**CHARLOTTE DOUGLAS INTERNATIONAL AIRPORT  
CHARLOTTE, NORTH CAROLINA**

**ADDENDUM NO. 2**

**NORTH END AROUND TAXIWAY (NEAT)  
OVERLOOK RELOCATION**

**CLT PROJECT NO. AVIA 23-50  
ADDENDUM DATE: MAY 25, 2023**

BOLLARD AND CHAIN BARRIER

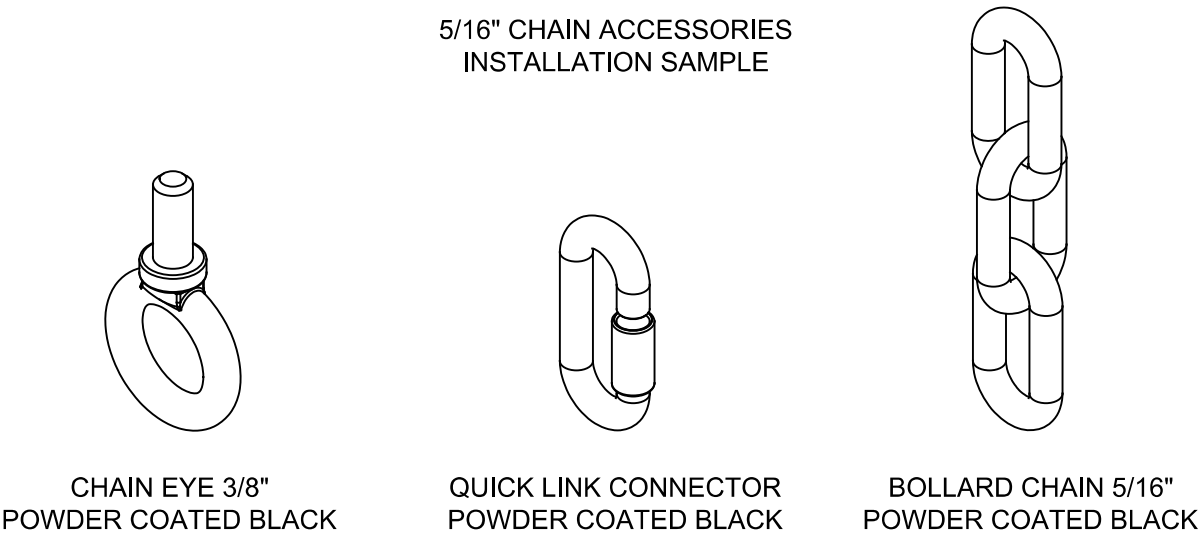
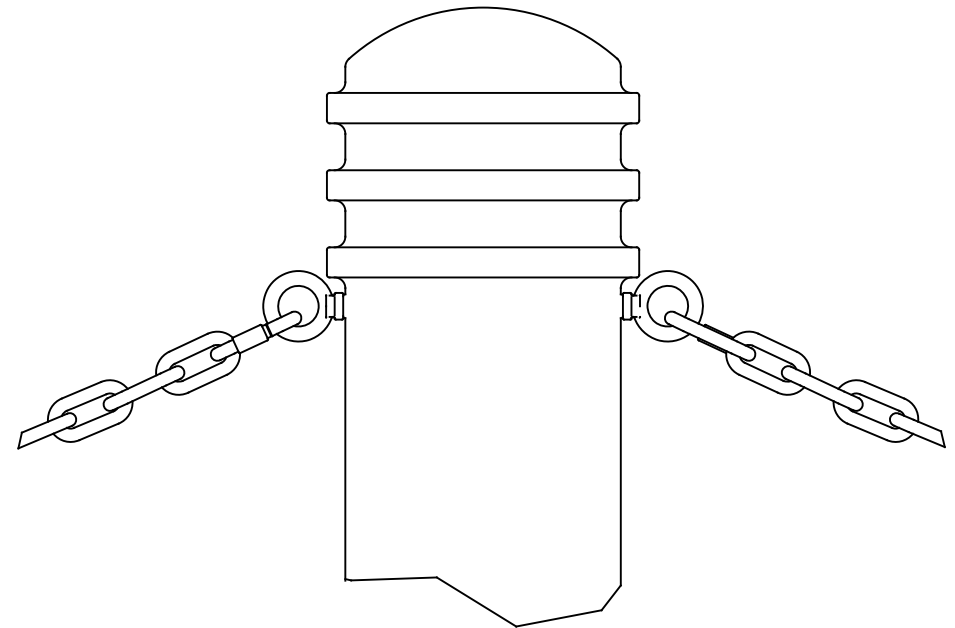
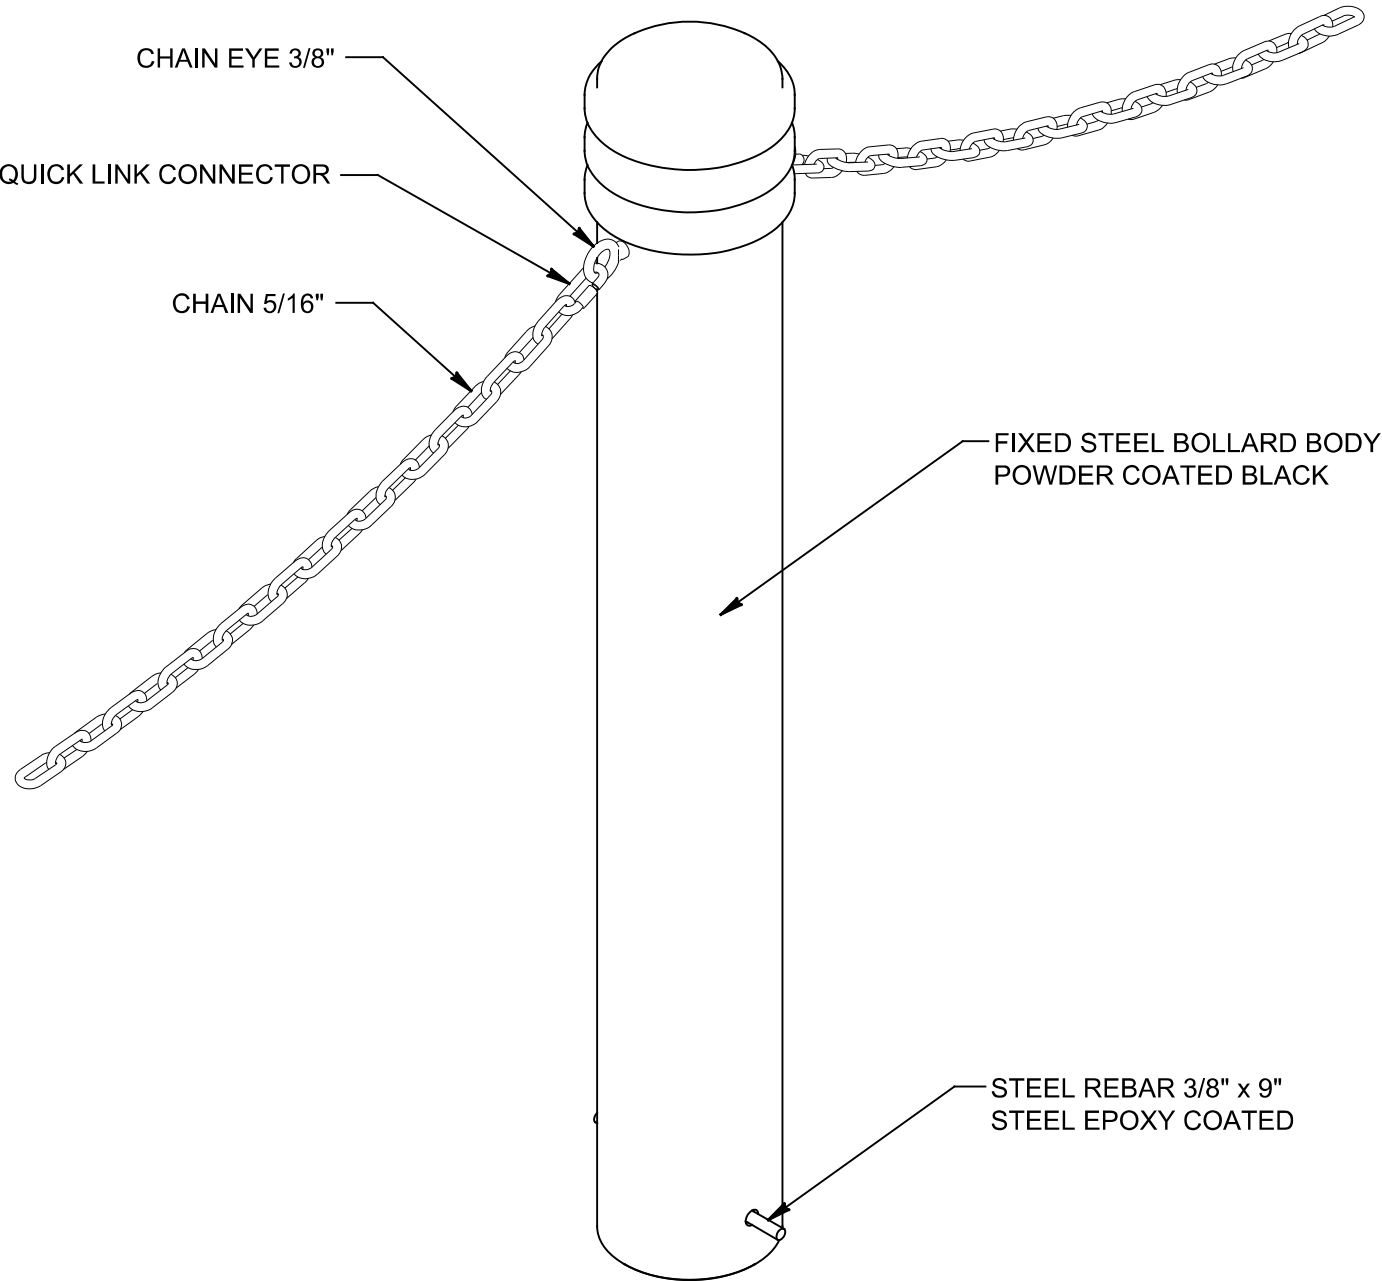
3. PROVIDE A METHOD TO PLACE A PADLOCK AT THE BOLLARD AND CHAIN BARRIER. COORDINATE THE LOCATION WITH CLT. THE PADLOCK WILL BE PROVIDED BY CLT.

SHT.  
3A-10

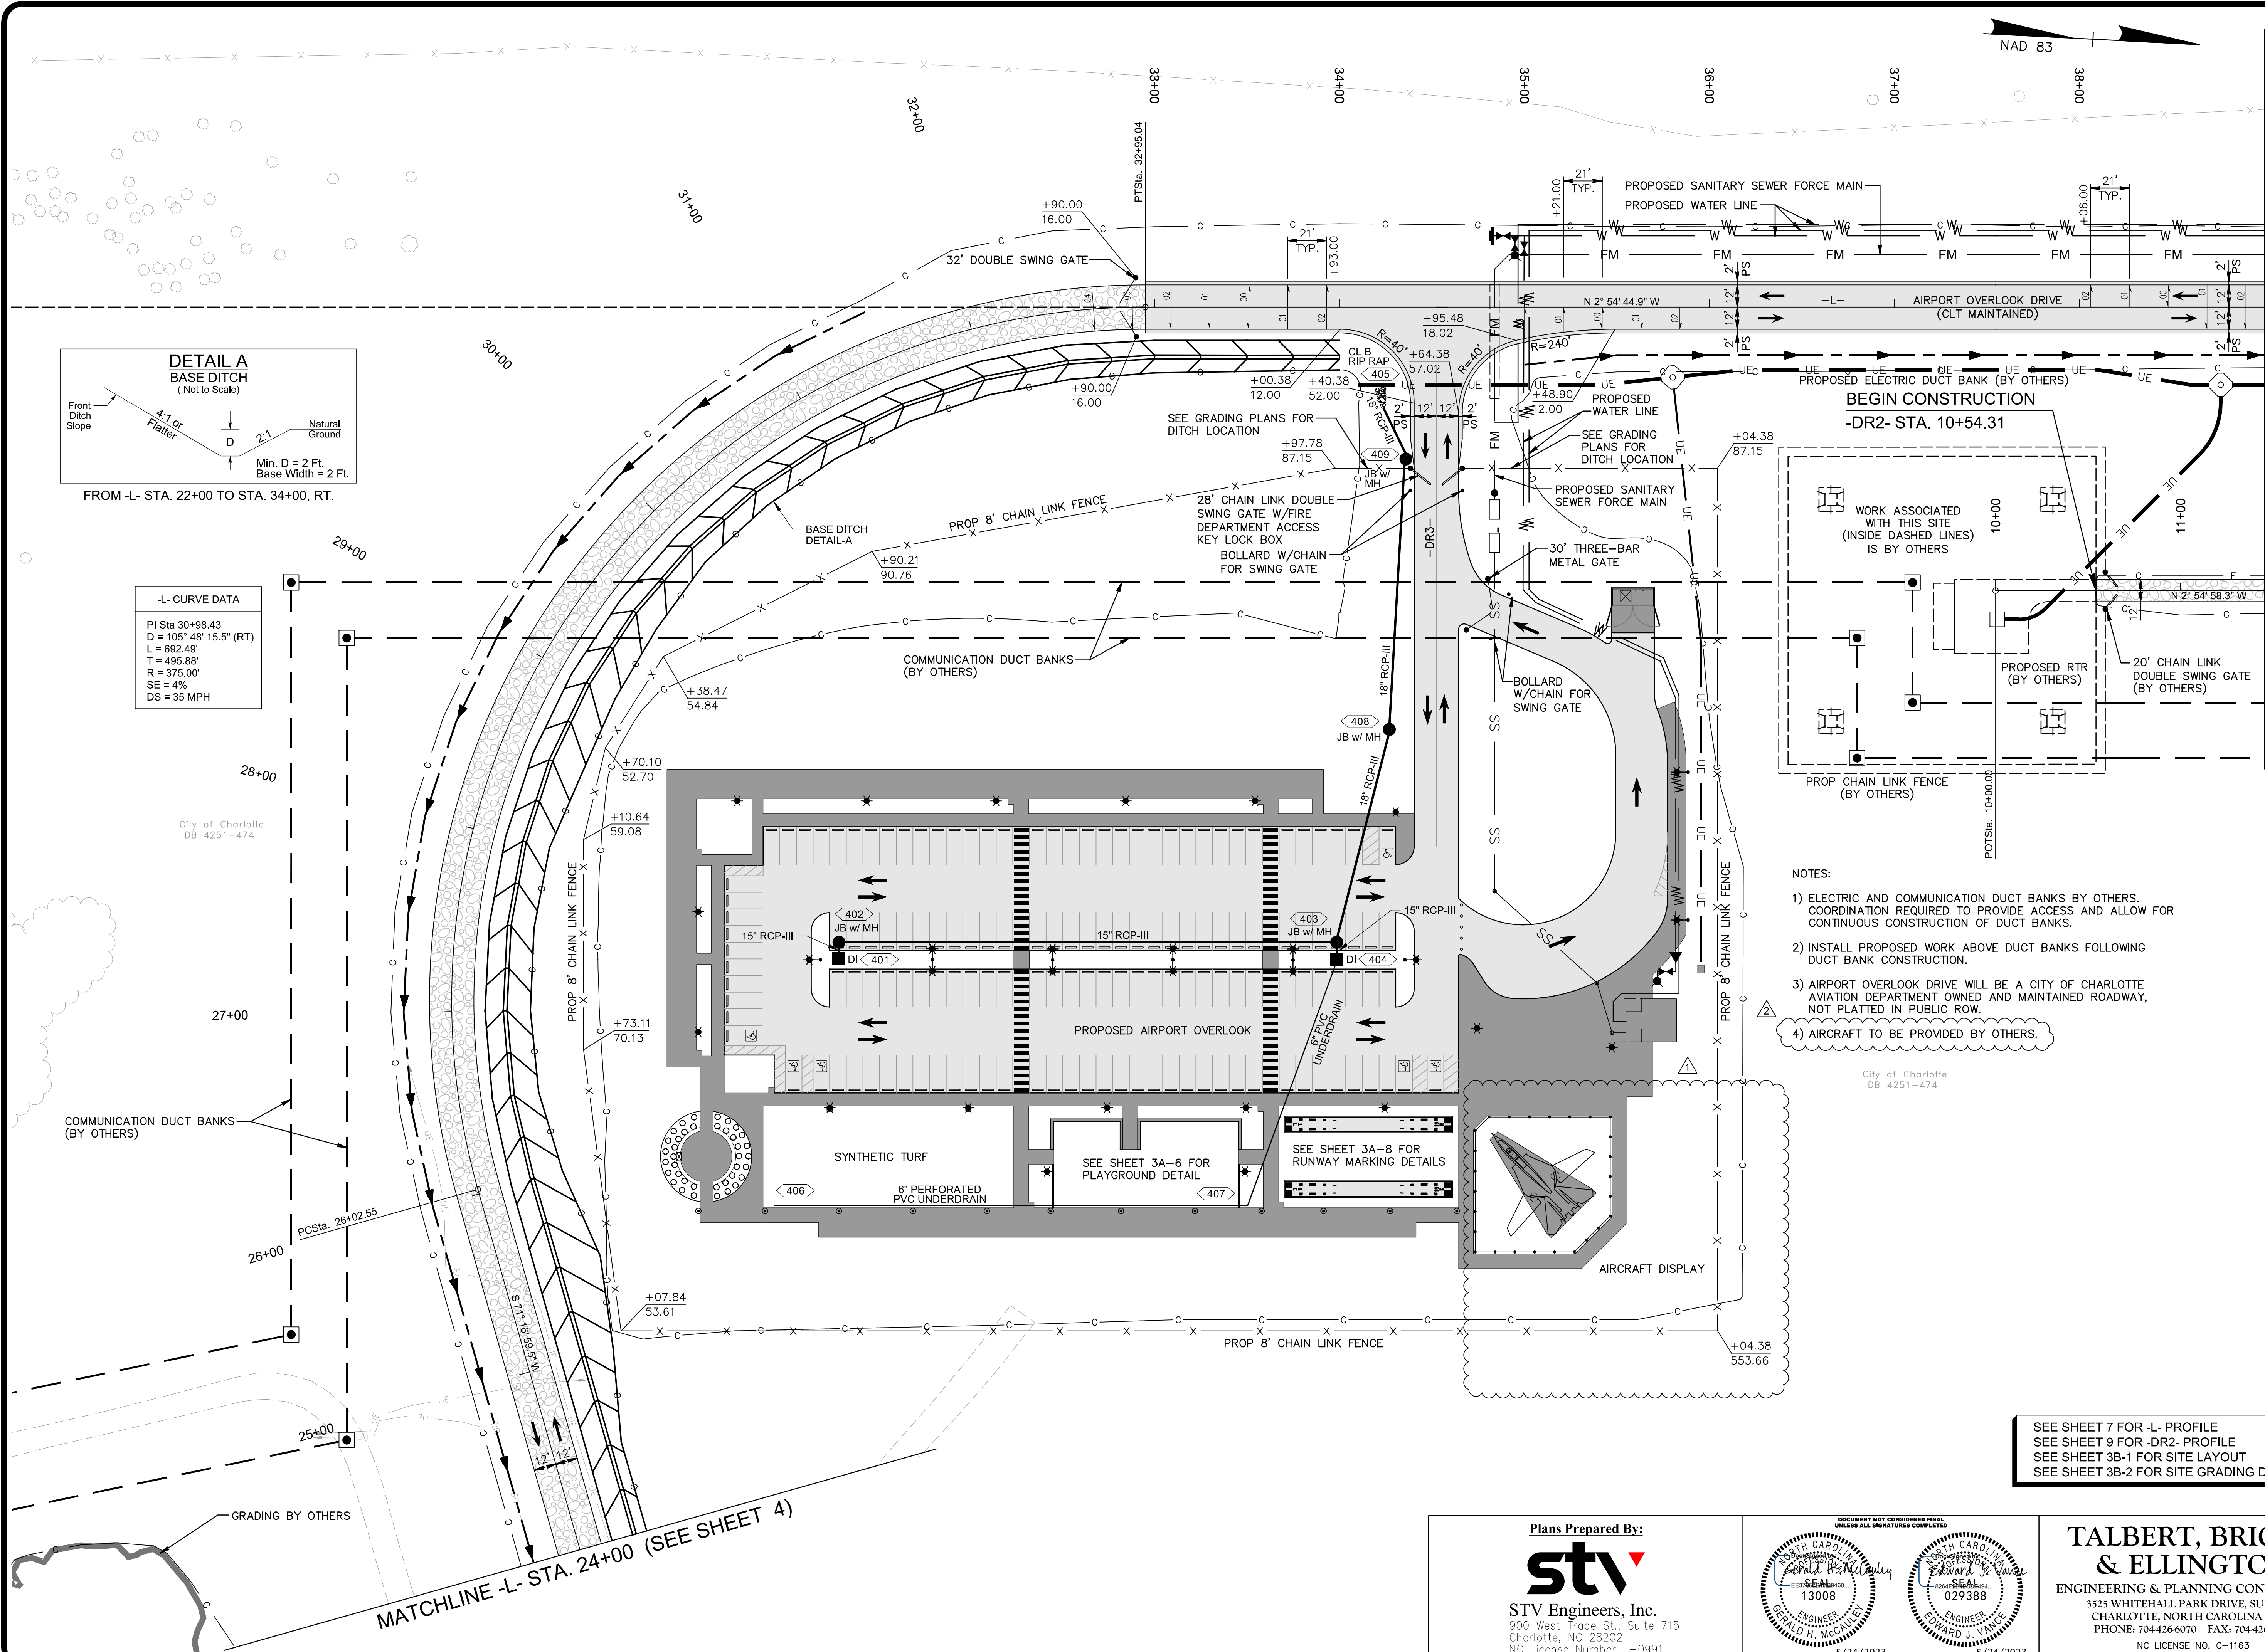
REVISIONS		DATE
1	ADDENDUM NO. 1 - REVISED AIRCRAFT DISPLAY AREA	05/15/2023
2	ADDENDUM NO. 2 - ADDED AIRCRAFT DISPLAY NOTE	05/25/2023
3		
4		
5

- NOTES:
- 1) ELECTRIC AND COMMUNICATION DUCT BANKS BY OTHERS. COORDINATION REQUIRED TO PROVIDE ACCESS AND ALLOW FOR CONTINUOUS CONSTRUCTION OF DUCT BANKS.
  - 2) INSTALL PROPOSED WORK ABOVE DUCT BANKS FOLLOWING DUCT BANK CONSTRUCTION.
  - 3) AIRPORT OVERLOOK DRIVE WILL BE A CITY OF CHARLOTTE AVIATION DEPARTMENT OWNED AND MAINTAINED ROADWAY, NOT PLATTED IN PUBLIC ROW.
  - 4) AIRCRAFT TO BE PROVIDED BY OTHERS.
